Professional Audio Service Bulletin

BULLETIN NO. 2

SUBJECT: Replacement of MURA type Meter Lamps

APPLICABLE TO: ALL M-79 Professional Audio Recorders

FIGURE 1

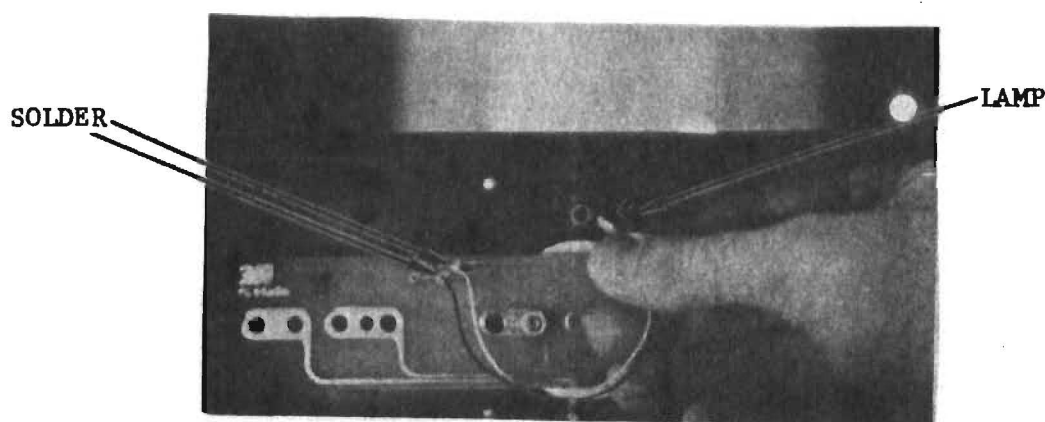
PURPOSE: Improved Lamp Reliability

- I. Remove MURA type meter lamp from the white line cap above the meter and unplug the wires from meter mother board.
- II. Solder wires on lamp holder 83-1620-0294 in place of the removed wires on the mother board (see Figure 1).

- III. Insert the lamp, type 388, in holder (83-1620-0294) and insert entire assembly in the white lens cap.
- IV. Future replacement of failed lamp will be accomplished by replacing the lamp only.

FIGURE 1

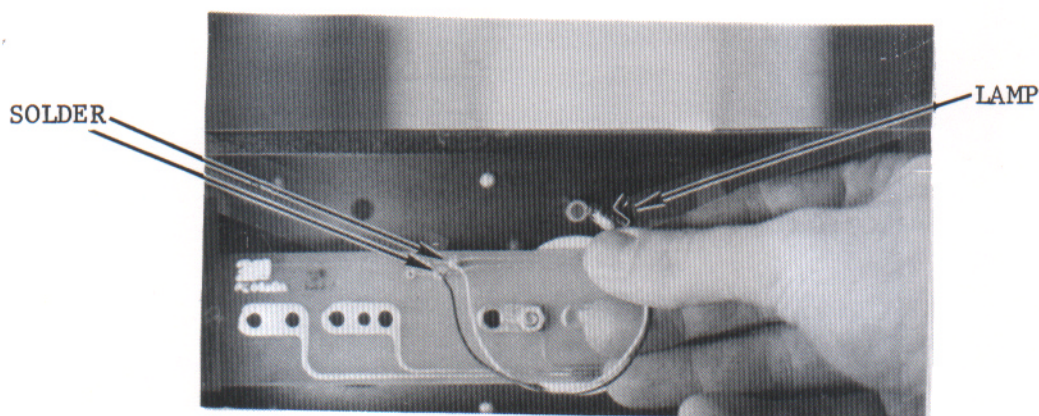
SUBJECT: Replacement of MURA type Meter Lamps

PURPOSE: Improved Lamp Reliability

- I. Remove MURA type meter lamp from the white line cap above the meter and unplug the wires from meter mother board.
- II. Solder wires on lamp holder 83-1620-0294 in place of the removed wires on the mother board (see Figure 1).

- III. Insert the lamp, type 388, in holder (83-1620-0294) and insert entire assembly in the white lens cap.
- IV. Future replacement of failed lamp will be accomplished by replacing the lamp only.
